Addendum 69: Regulation No. 70

Amendment 1

UNIFORM PROVISIONS CONCERNING THE APPROVAL OF REAR MARKING PLATES FOR HEAVY AND LONG VEHICLES

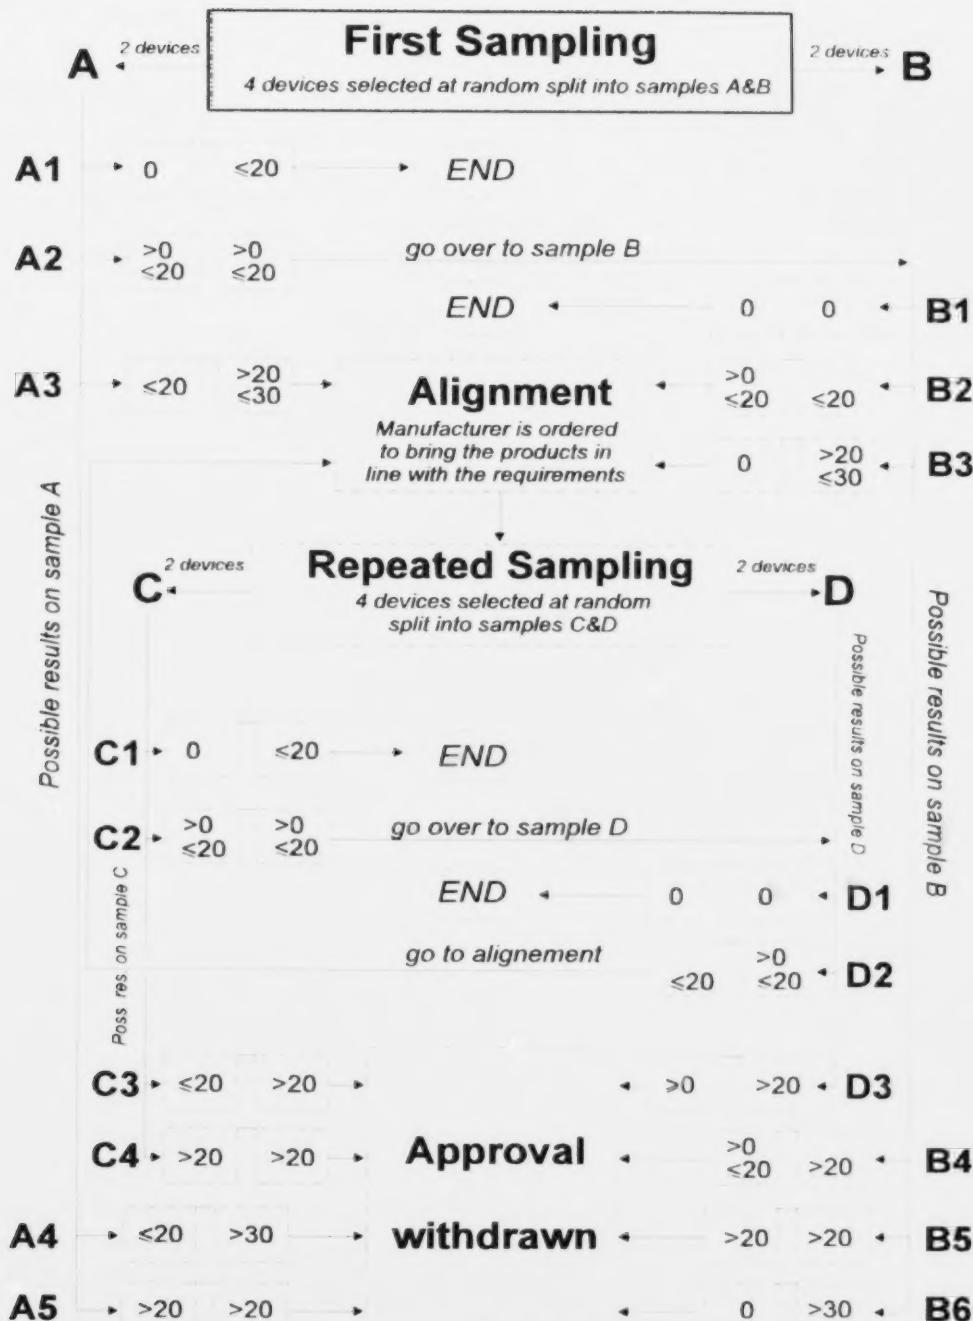
- 2.1.1. Following the sampling procedure shown in Figure 1 of this annex the conformity of mass-produced rear marking plates shall not be contested if the deviation of the measured values of the rear marking plates in the unfavourable directions are:

2.2.1. Following the sampling procedure shown in Figure 1 of this annex the conformity of mass-produced rear marking plates shall be contested and the manufacturer requested to make his production meet the requirements (alignment) if the deviations of the measured values of the rear marking plates are:

Conformity shall be contested and paragraph 10 applied if, following the sampling procedure in Figure 1 of this annex, the deviations of the measured values of the rear marking plates are:
